BULLETIN # 1 4

PROJECT: Harrison Recreation & Community Center – PHASE 2
Harrison, NY

RE: Relocate Rebar at Col Line A.1

ASK-17 RELOCATE REBAR AT COL LINE A.1

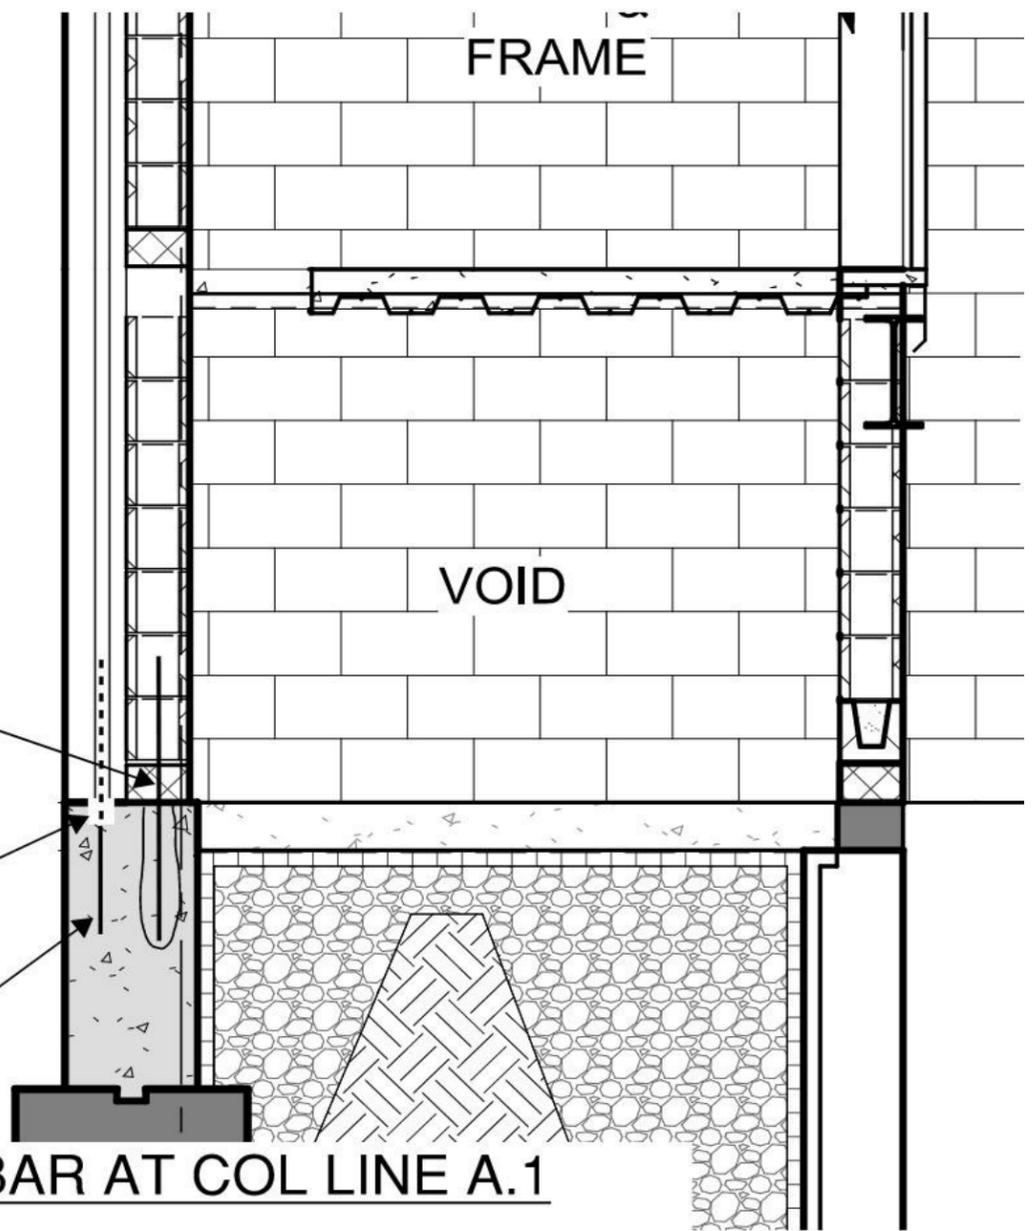
Please see the attached sketch illustrating the relocation of rebar at Column Line A.1 that was placed incorrectly in Phase 1. Currently the in place rebar intended for the CMU wall at Col line A.1 is located where the brick veneer is to be. Contractor to chip out concrete at mislocated bars to allow cutting of the in place bars approximately 2” below the top of wall. Contractor to infill where rebar removed with appropriate concrete bonding primer and repair mortar by Sika or equal.

Contractor to epoxy-drill in new re-bar in the location of the CMU back up wall maintaining the O.C. spacing and height. Embed #5 rebar minimum 6” and anchor with Hilti HY 200 anchor adhesive.

EPOXY DRILL NEW REBAR INTO FOUNDATION CENTERED ON THE CMU WALL- EMBED 6" MIN IN HILTI HY 200 ADHESIVE

CUT IN PLACE REBAR APPROX. 2" BELOW TOP OF FOUNDATION WALL- PATCH WITH CONCRETE BONDING PRIMER AND REPAIR MORTAR BY SIKA OR EQUAL

LEAVE CAST IN PLACE SECTION IN PLACE
